Agenda Item # 4 SUB-003054-2024

Ruby Moore Subdivision

- Subdivision approval to create one (1) legal lot of record from one (1) metes-and-bounds parcel.

DETAIL SITE PLAN

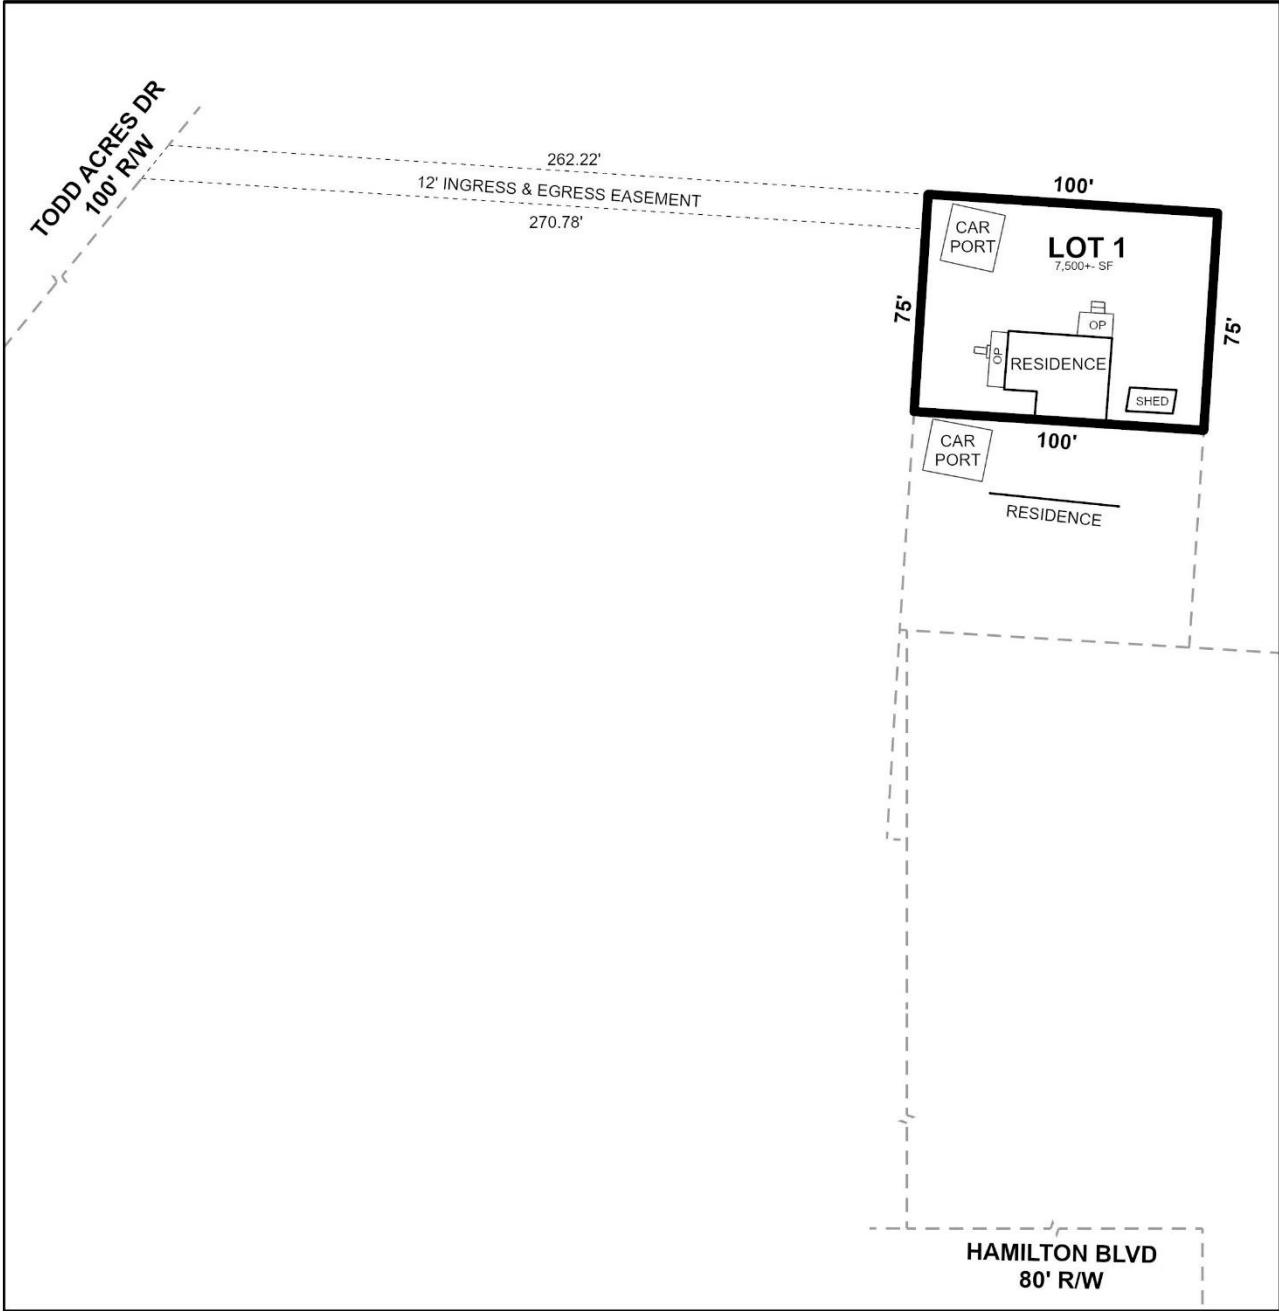
The proposed lot does not abut a public street, as required by Section 6.C.4. of the Subdivision Regulations. Instead, access is facilitated by a recorded 12-foot wide ingress/egress easement to Todd Acres Drive. Considering the property appears to have existed in its current configuration prior to annexation, and was developed prior to current regulations, a waiver of Section 6.C.4. of the Subdivision Regulations may be appropriate.

No front yard setback is provided. Section 6.C.8. of the Subdivision Regulations requires front yard setbacks to be illustrated on the Final Plat along any street as required in the Unified Development Code (UDC); however, because the proposed lot does not have street frontage, a waiver of Section 6.C.8. of the Subdivision Regulations may be appropriate.

If the Subdivision request is considered for approval, a waiver of Sections 6.C.4. and 6.C.8. of the Subdivision Regulations will be required, and the following conditions should apply:

1. Retention of the lot's size in square feet and acres on the Final Plat, or provision of a table on the Final Plat with the same information;
2. Compliance with all Engineering comments noted in this staff report;
3. Placement of a note on the Final Plat stating the Traffic Engineering comments noted in this staff report;
4. Compliance with all Urban Forestry comments noted in this staff report; and
5. Compliance with all Fire Department comments noted in this staff report.
